**Subject: Beaver Valley Power Station, Unit No. 2  
BV-2 Docket No. 50-412, License No. NPF-73  
Responses to a Request for Additional Information  
(RAI dated March 2, 2006) in Support of  
License Amendment Request No. 202**

### Response to Request for Additional Information Beaver Valley Power Station, Unit No. 2 Station Battery Charger Upgrade

**Updated Final Safety Analysis Report  
Changes for Station Battery Charger Upgrade**

Sheet 1 of 1	IDCN Rev. 0	
			Affected Drawing: RE-1AW	Unit 2	Rev. 19
			Engineering Change: ECP 02-0376		
			Implementation Document No.: 03		
B. Paul Preparer	R. C. Lubert Supervisor	C. V. Mancuso Manager/Date (Print name and sign and date)	IDCN No. <b>2-RE-0001AW-E02-0376-03</b>

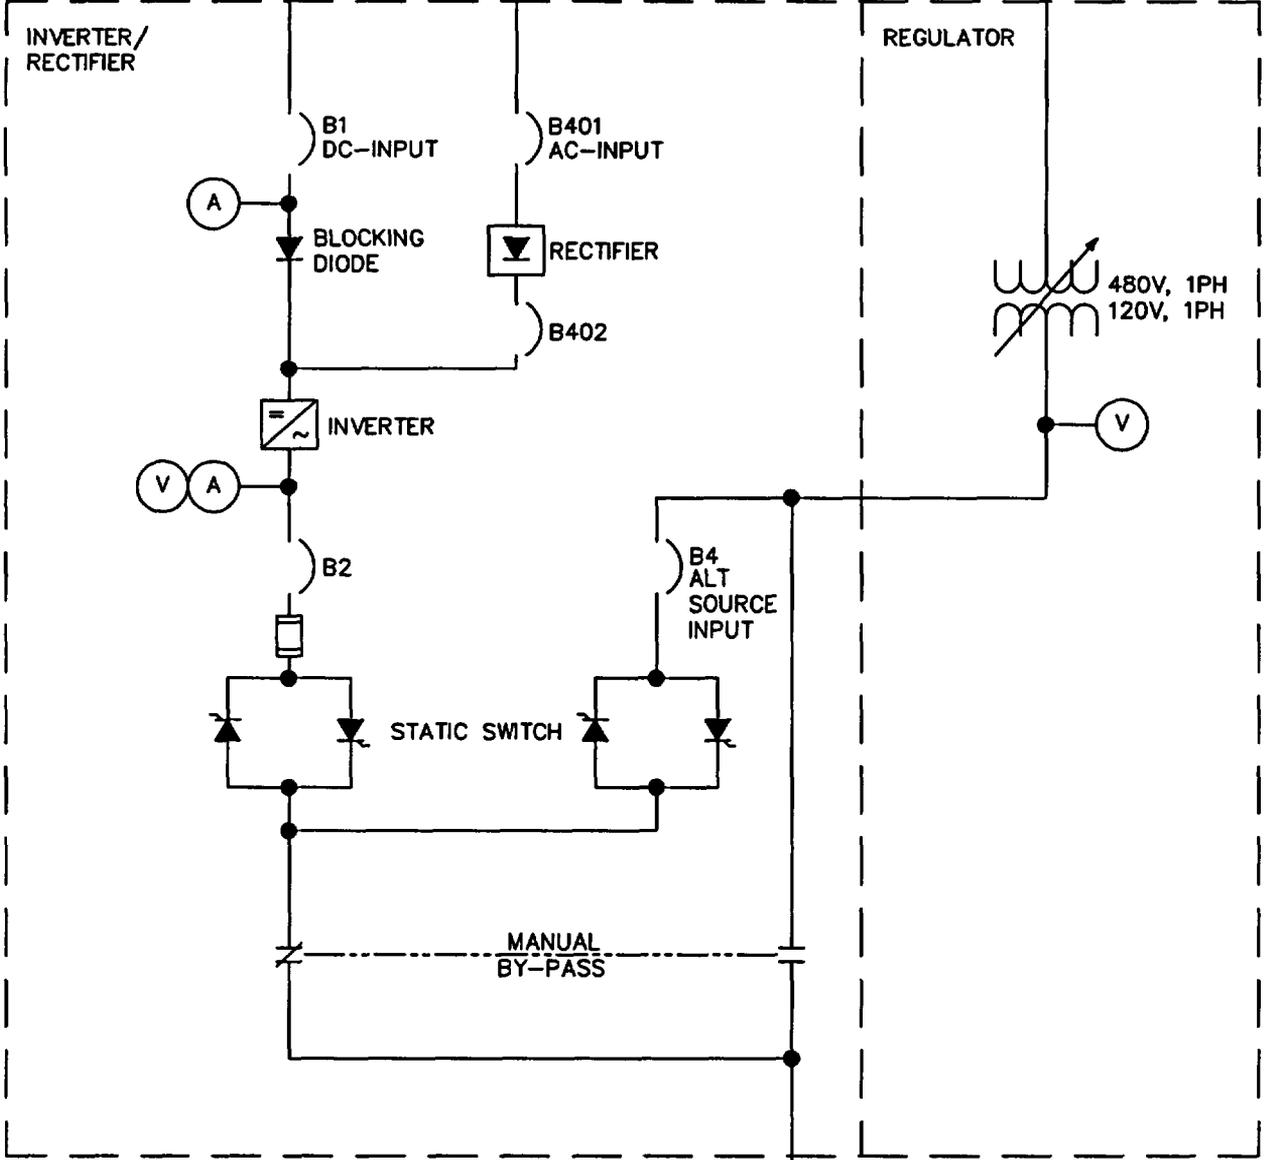
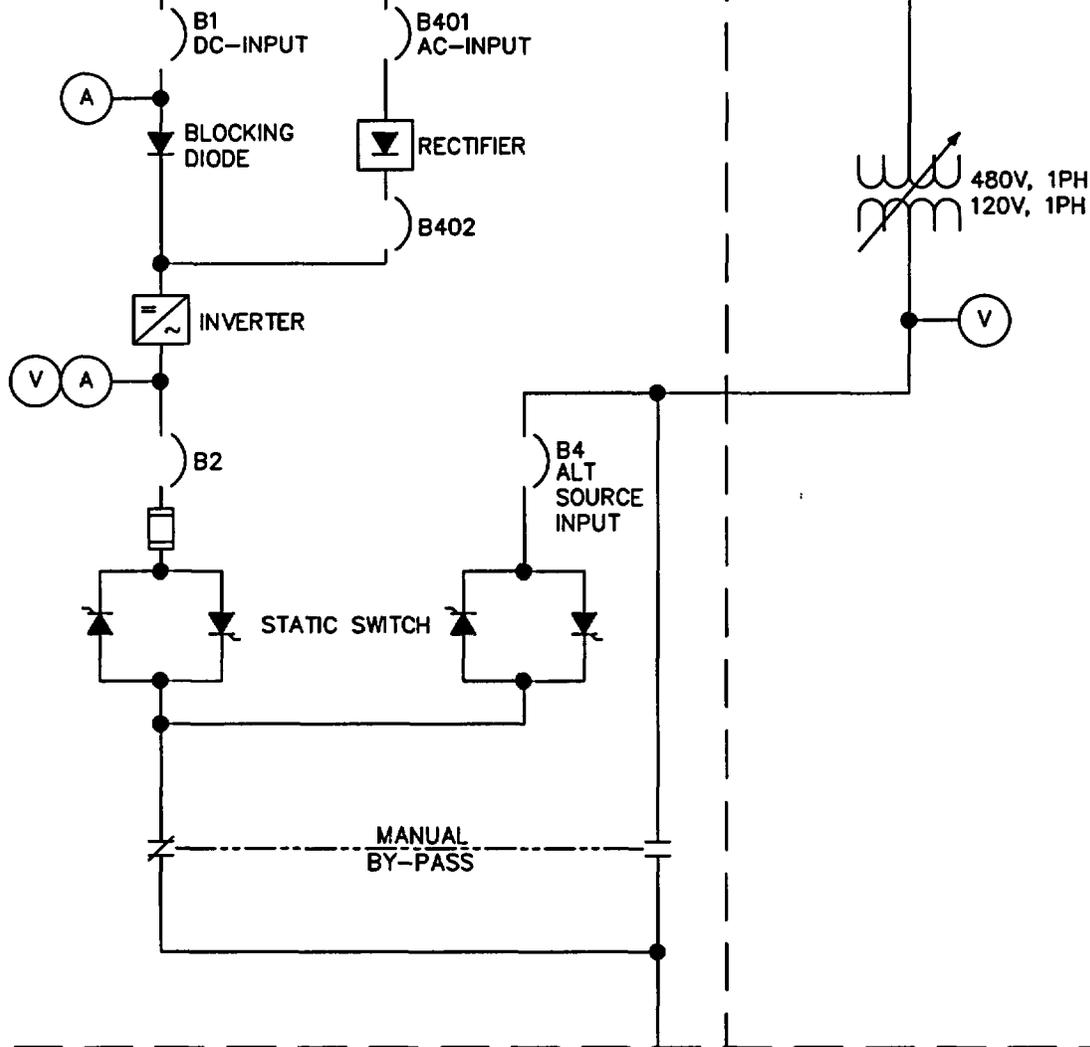
**5. How will you prevent the rectifier assemblies from providing direct current input to the respective 125 Volt direct current bus?**

Refer to the preliminary updated BVPS Unit No. 2 UFSAR Figures 8.3-3 and 8.3-14, provided for information in the attachment to letter L-06-046, and note the location of the "Blocking Diodes."

The existing UPS units for Vital Busses 2-1 (Red) and 2-2 (White) contain a rectifier, an inverter and a blocking diode. This figure revision which adds the blocking diodes to Busses 2-1 and 2-2 does not reflect a physical plant change, or a change associated with License Amendment Request No. 202. The addition of the blocking diodes to busses 2-1 and 2-2 are intended as an editorial change to reflect the existing equipment configuration.

FIGURE B.3-14  
 CLASS 1E 125 VDC  
 DISTRIBUTION SYSTEM  
 BEAVER VALLEY POWER STATION - UNIT 2  
 FINAL SAFETY ANALYSIS REPORT

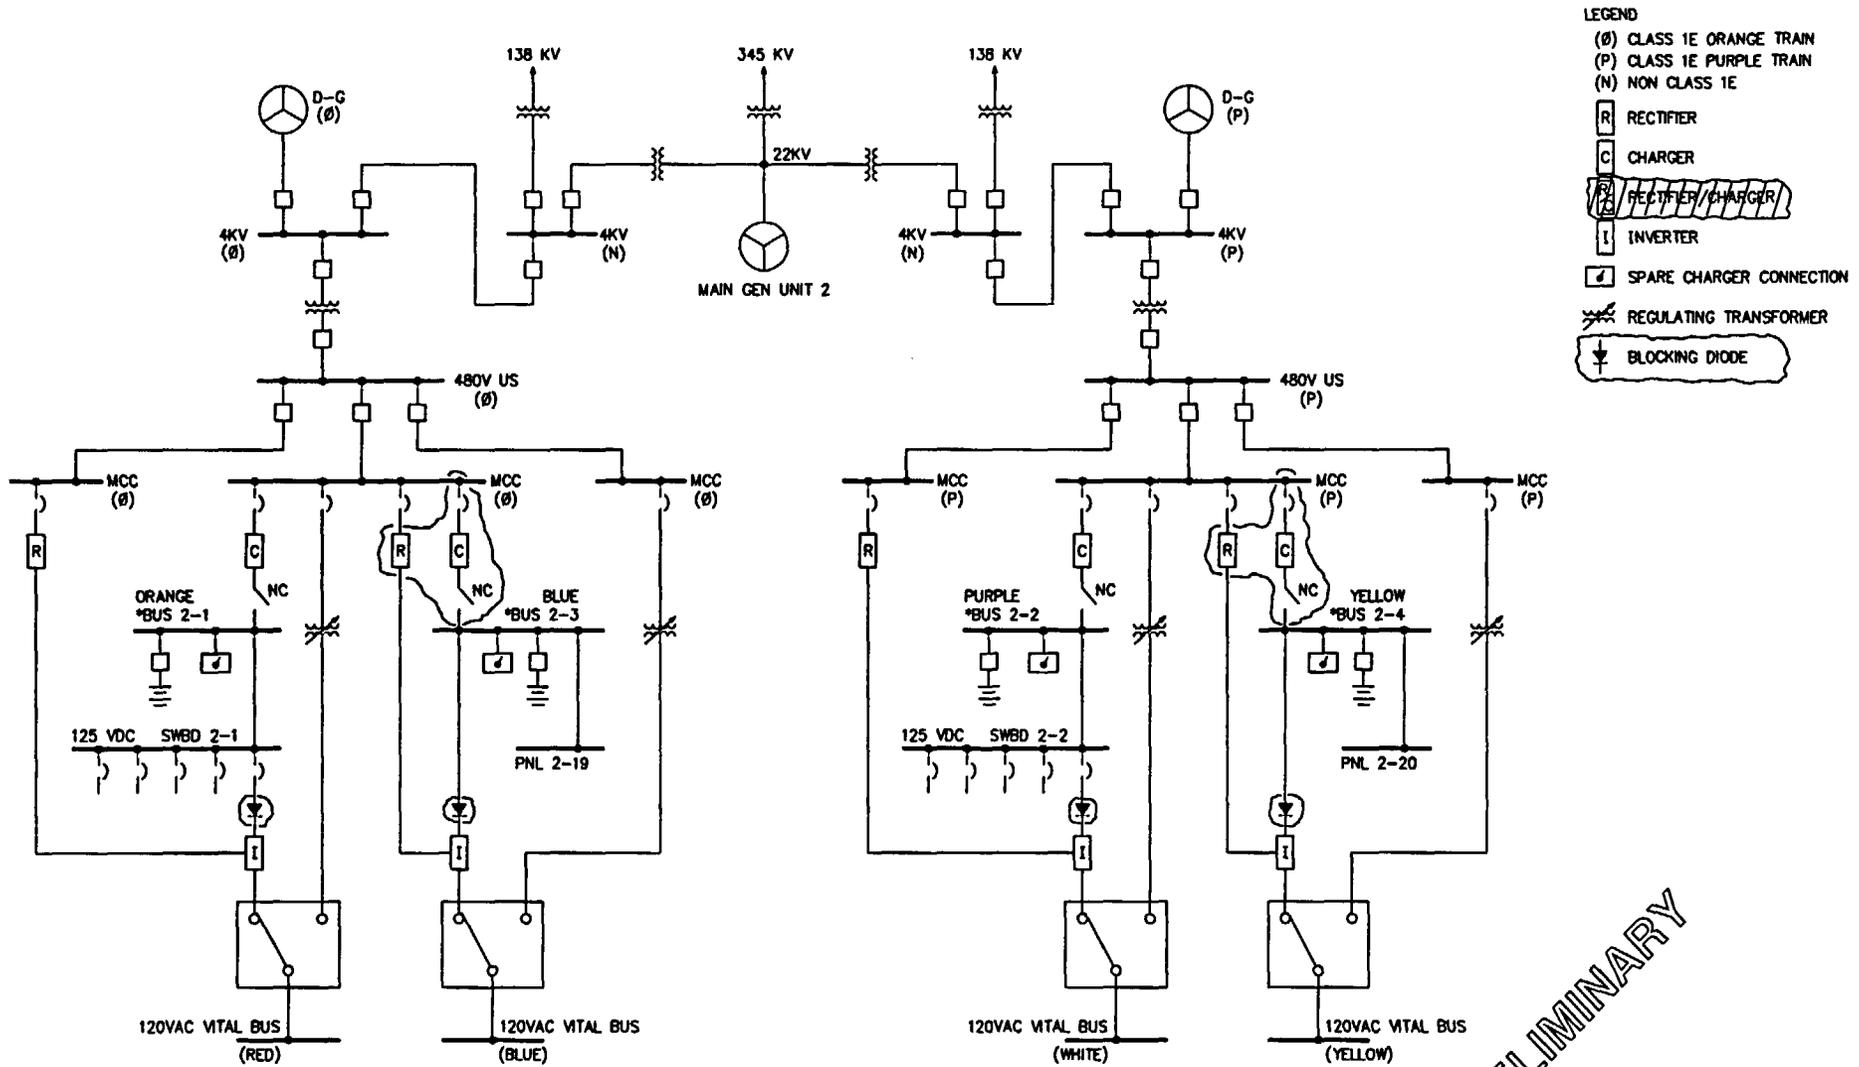
**4. Provide an updated electrical one-line diagram that shows the proposed design configuration.**

Attachment 1 includes Figure 8.3-14, "Class 1E 125-VDC Distribution System." This figure provides the requested one-line diagram showing the proposed design configuration. Changes are shown within revision clouds.

The function of the blocking diode is to prevent the UPS rectifier output from providing direct current input to the respective 125 Volt DC Bus. DC bus voltage is set slightly lower, upstream of the blocking diode, to prevent the DC bus from providing power to the Vital Bus loads during normal system operation. Upon loss of sufficient rectifier output, the DC bus will provide power to the associated Vital Bus loads, via the battery charger output if available or ultimately from the batteries.
